The U.S. Geological Survey is herein responding to your request for additional information (TAC No. MC5120) dated March 10, 2005. This concerns the USGS amendment request to its research reactor facility license (No. R-113, Docket 50-274) to allow the use of aluminum-clad TRIGA fuel in the core.

REQUEST FOR ADDITIONAL INFORMATION UNITED STATES GEOLOGICAL SURVEY DOCKET NO. 50-264

FIGURE III-21

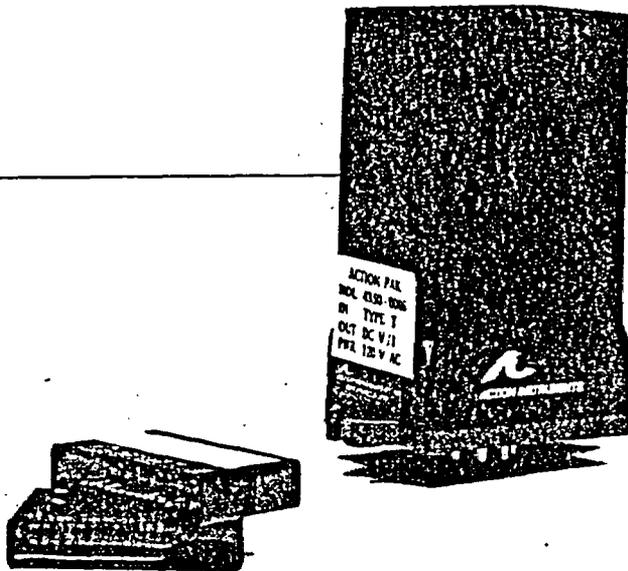
The other error occurs from the thermocouple not being at the actual location of peak temperature in the fuel element. For steady state operations, this error is from vertical mispositioning and it is approximately 10°C. During pulsing operations this error is 25% of the measured temperature. The error during pulsing is larger because it is a radial positioning error during the rapid transient: i.e., the peak temperature occurs near the fuel cladding and not at the element centerline. For example, during pulsing operations an indicated temperature of 400°C would equal an actual peak temperature in the fuel element of 500°C. This information is taken from Figure III-21 of the University of Illinois Safety Analysis Report, dated 1969. This figure is attached.

This potential inaccuracy impacts our response as follows: For steady state operations, it should be assumed that the peak fuel temperature is really 15°C higher than indicated. Since none of the allowed

steady state operations show that the F or G-ring temperatures are within 15°C of the 500°C proposed limit (see Table in Question 1 response above), there is no impact to the operational safety.

During pulsing operations, the expected measured fuel temperature in the F-ring from a \$3.00 pulse is 233°C. Applying the expected error of 25% plus 5°C instrument error gives a true peak fuel temperature of 296°C, much less than the 500°C proposed limit. The G-ring temperature would be less, at 227°C true peak temperature (see table below). Therefore the impact of these errors on the temperatures in our previous answers is that the temperatures are still well below the safety system limit of 500°C and there is no impact to the operational safety of the GSTR.
